Access Compliance Report

Public Rights-of-Way

Intersection ID: 10035022	Main Street: PROVIDENCE_RD	Cross Street: N/A	Location: NW
ADA ID: 56A6ADBC78C9	Ramp Type: BlendTrans2	Initial Pass/Fail: Fail	Overall Compliance: No
			Severity Score: 33.75

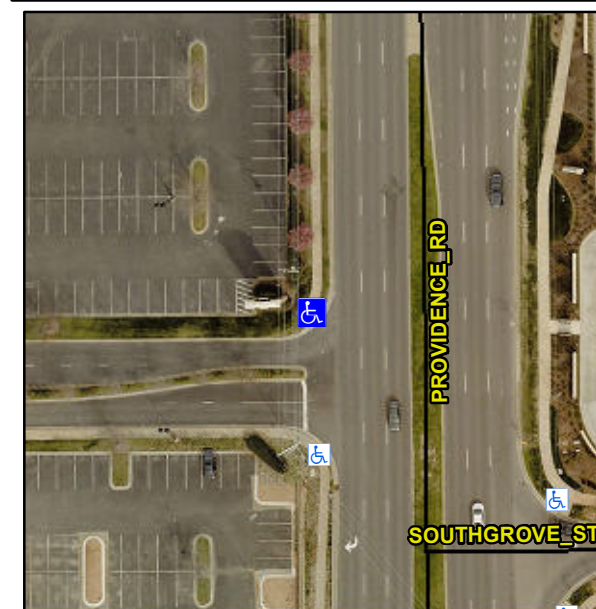
Not Found, R304.5.1, R304.5.3

Compliance	Description	Data	Compliance	Description	Data
N/A	Ramp Length (in)	107.0	Yes	BlendTrans Slope (%)	2.2
No	Ramp Width (in)	43.0	No	BlendTrans XSlope (%)	7.0
N/A	Flare Type LT	N/A	N/A	Flare Type RT	N/A
N/A	Flare Slope LT (%)	N/A	N/A	Flare Slope RT (%)	N/A
N/A	Flare Traversable LT?	N/A	N/A	Flare Traversable RT?	N/A
N/A	Landing Length (in)	N/A	N/A	DWS Provided?	N/A
N/A	Landing Width (in)	N/A	N/A	DWS Contrast?	N/A
N/A	Landing Slope (%)	N/A	N/A	DWS Length (in)	N/A
N/A	Landing X Slope (%)	N/A	N/A	DWS Full Width?	N/A
N/A	Landing Curb? (Y/N)	N/A	N/A	DWS Offset (in)	N/A
N/A	Shared Landing?	N/A			
N/A	Gutter Ponding?	N/A	N/A	Gutter Slope (%)	N/A
N/A	Gutter Lip Ht (in)	N/A	N/A	Gutter X Slope (%)	N/A
N/A	Painted X Walk1?	No	N/A	Painted X Walk2?	N/A
	X Walk 1 Direction	To S		X Walk 2 Direction	N/A
	X Walk 1 Width (in)	N/A		X Walk 2 Width (in)	N/A
	X Walk 1 Slope (%)	2.8		X Walk 2 Slope (%)	N/A
	X Walk 1 X Slope (%)	1.0		X Walk 2 X Slope (%)	N/A

N/A	Ramp inside XWalk1?	N/A	N/A	Ramp inside XWalk2?	N/A
	Road Slope (%)	1.0		Clear Space?	N/A
	Road X Slope (%)	2.8	N/A	Clear Space to XWalk (in)	N/A
N/A	Any Obstructions?	N/A	N/A	Storm Grate/Utility Hazard?	N/A
	Obstruction Type			Storm Grate/Utility Type	
		N/A			N/A
			Yes	Surface Condition? (G/P)	Good
			No	Curb Slope (%)	12.0

Remove & Replace Curb Ramp With Two New Directional Ramps or Equivalent.
